TRANSPORT ASSESSMENT & TRAVEL PLAN ADDENDUM

Viadux Phase 2 Minor Material Amendment

VN201568

Transport Statement and Framework Travel Plan Addendum

Dwg 10053-B3-A-B5D9-G200-P-00-001 Viadux Phase 2 Ground Floor Layout

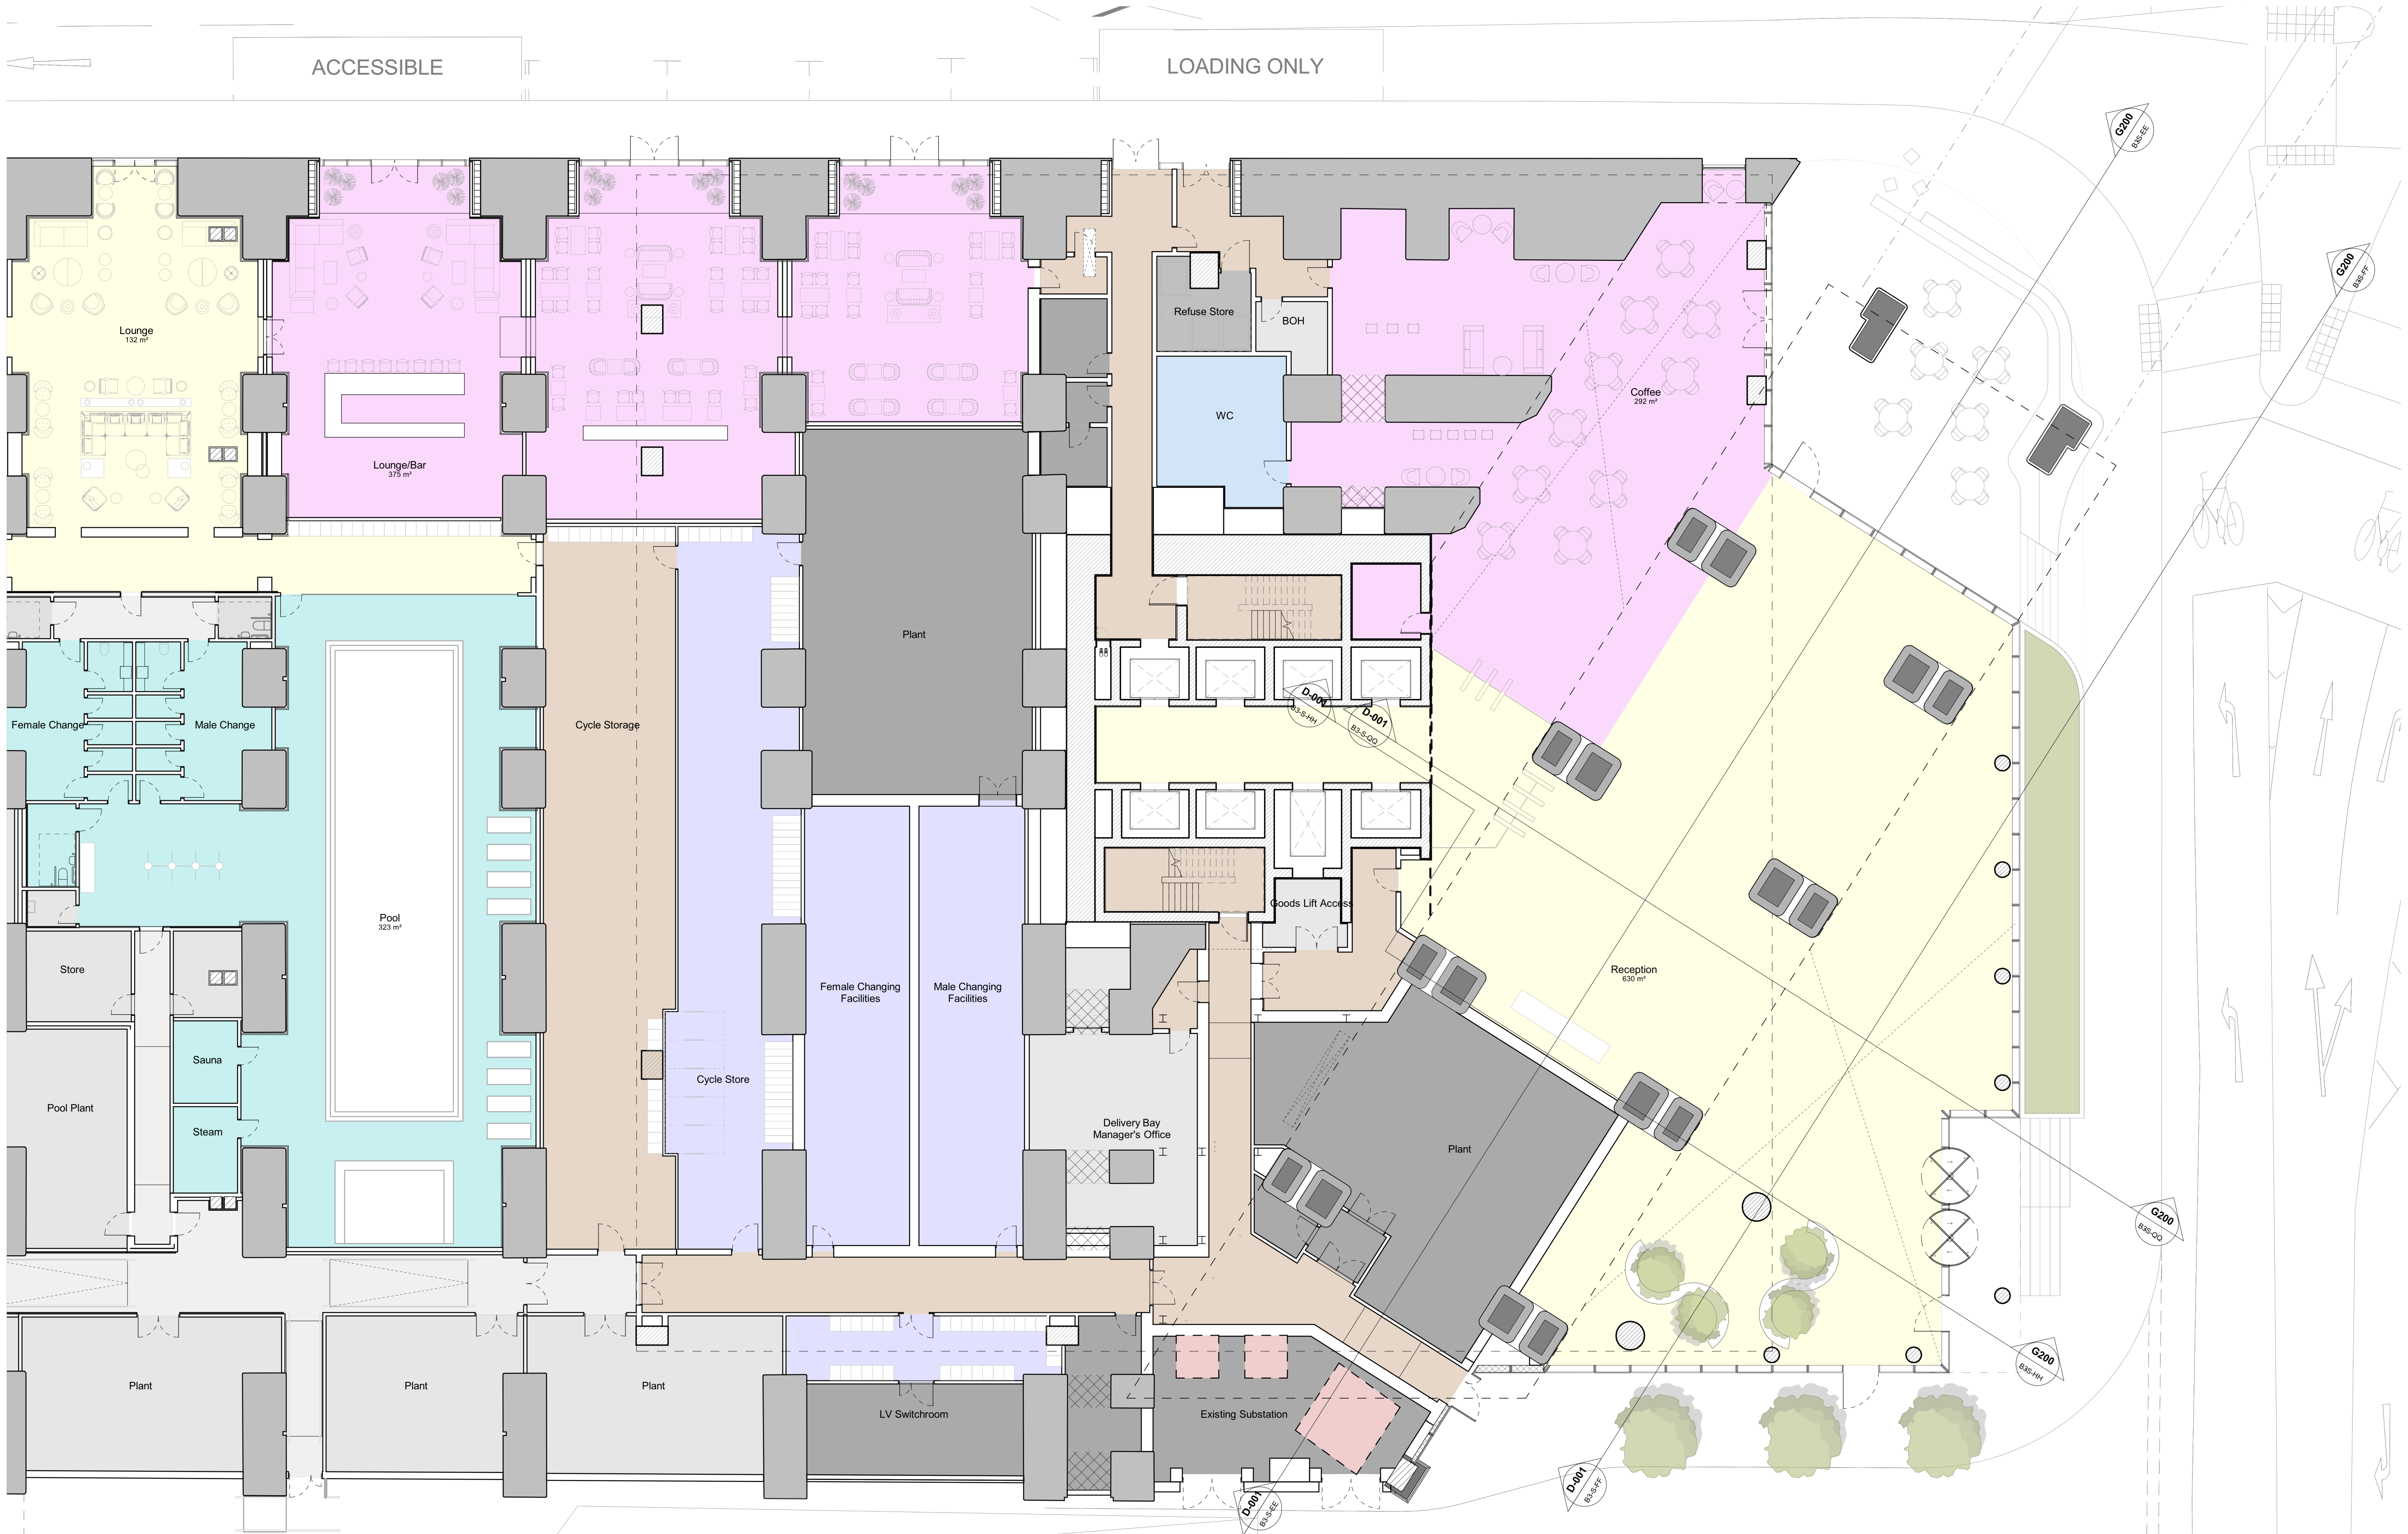
- 2.7 The proposed ground floor layout for the office Building B2 is shown in **Dwg 10053-B3-A-B5D9-G200-P-00-001**. It can be seen here that the cycle store for the office workers is now adjacent to that for the Residents and that this is accessed from Albion Street.
- 2.8 The number of cycle spaces for the office workers has increased to 267 spaces (up from 114) while the residential cycle parking remains at 375 or one space per apartment.
- 2.9 The plan also shows the entrance detail and the coffee shop to the north.

Drg No. 2840-PLA-XX-00-DR-L-0001 Suitability S1 Revision P05

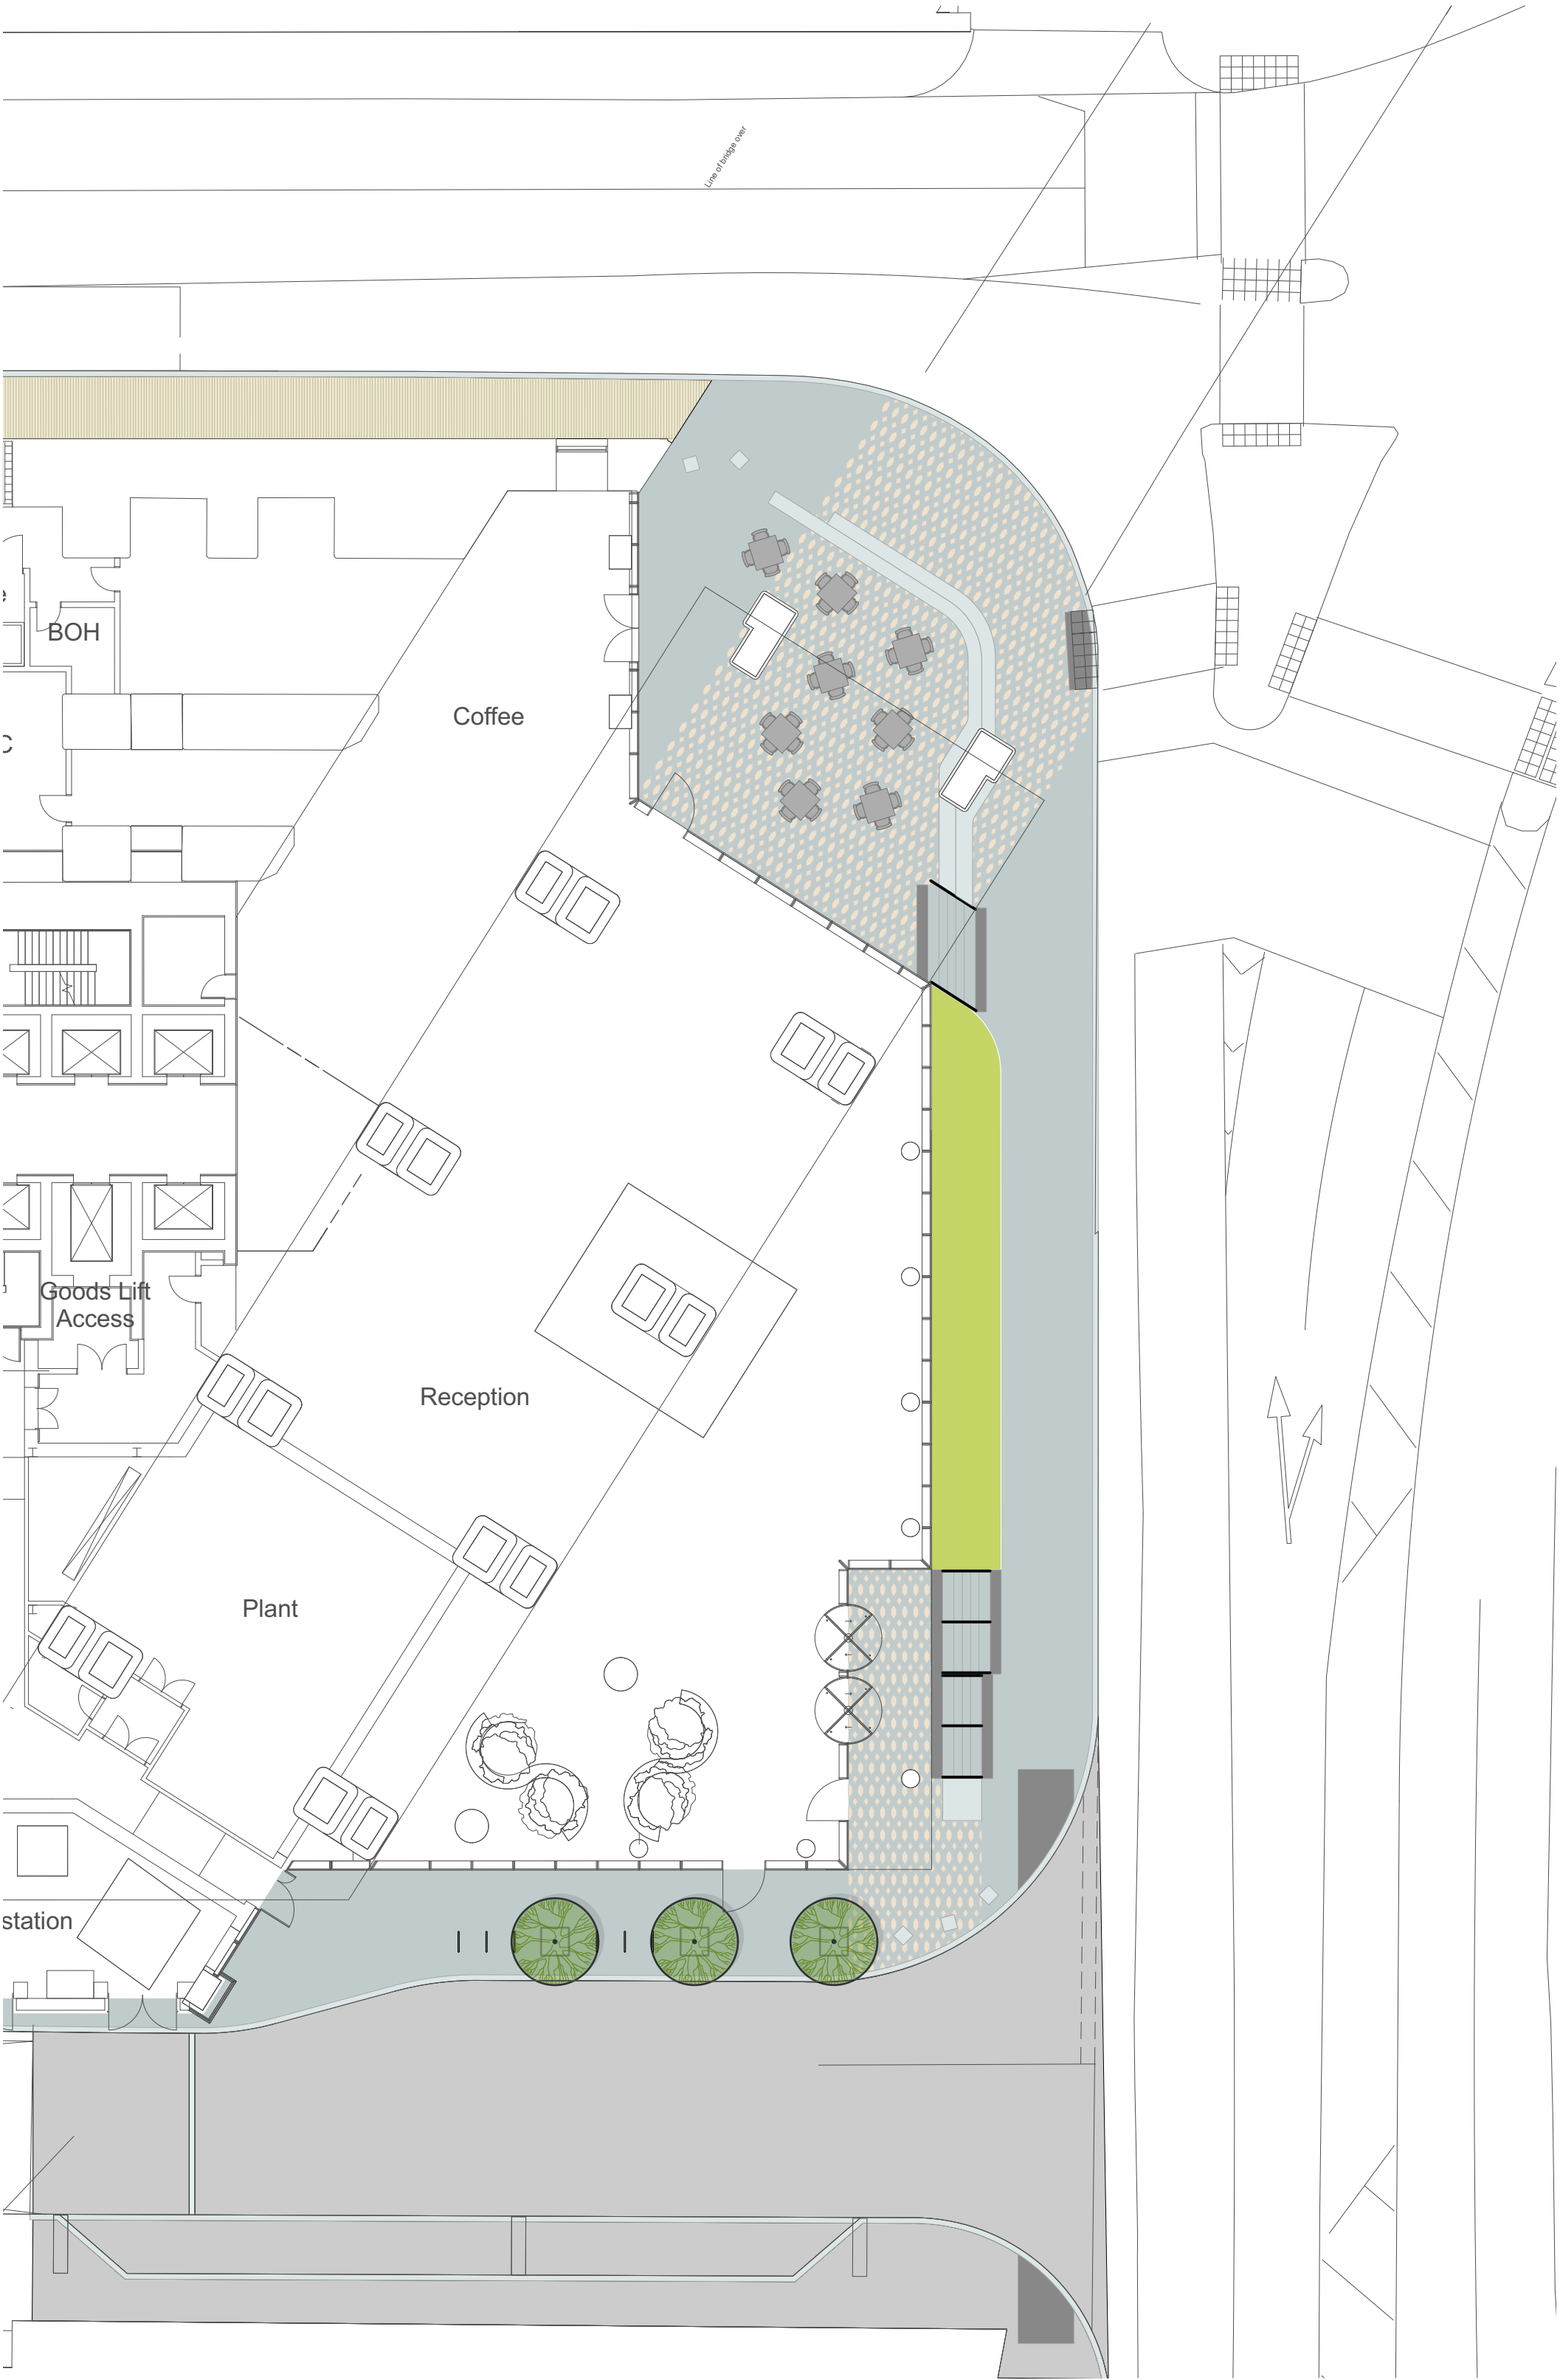
- 2.10 The public realm changes on Albion Street are explained in the Planit-ie submission and an extract of the changes are given in **Appendix B**. The detail of the public realm proposals are shown in **Dwg 2840-PLA-XX-00-DR-L-0001**.
- 2.11 The omission of the loading bay allows an improved public realm and entrance to the building. The paving surface will be of a high quality. There are level differences to negotiate and consequently there are some steps included alongside step free approaches. There is external seating outside the coffee shop under the tram bridge and there is now soft landscaping in front of the building. There are three trees to the south of the building (a loss of one compared to the approved scheme) and visitor parking provided (12 spaces) in Sheffield cycle stands (with tapping rail).
